Change Item Description	Current	New
LSP05GI Module Series: UL 1449 Recognition	120V, 240V, 277V	120V, 240V, 277V, 347V, 480V
Product Label on the product		
Packaging Label on the Inner packaging box

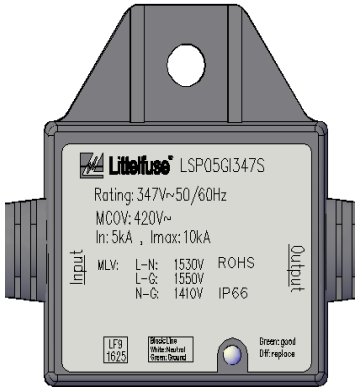
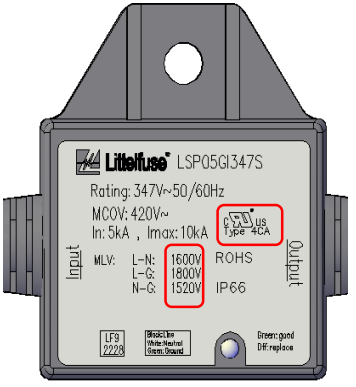
Affected Part Number	Current MLV Rating	New MLV Rating
LSP05GI347*	L-N: 1530V	L-N: 1600V
	L-G: 1550V	L-G: 1800V
	N-G: 1410V	N-G: 1520V
LSP05GI480*	L-N: 1800V	L-N: 1910V
	L-G: 1900V	L-G: 2020V
	N-G: 1410V	N-G: 1660V

Added 347V and 480V rating based on the latest UL 1449 test and product recognition information.

Added cURus Logo and Updated MLV rating based on the latest UL 1449 test result and product recognition information.

Added cURus Logo
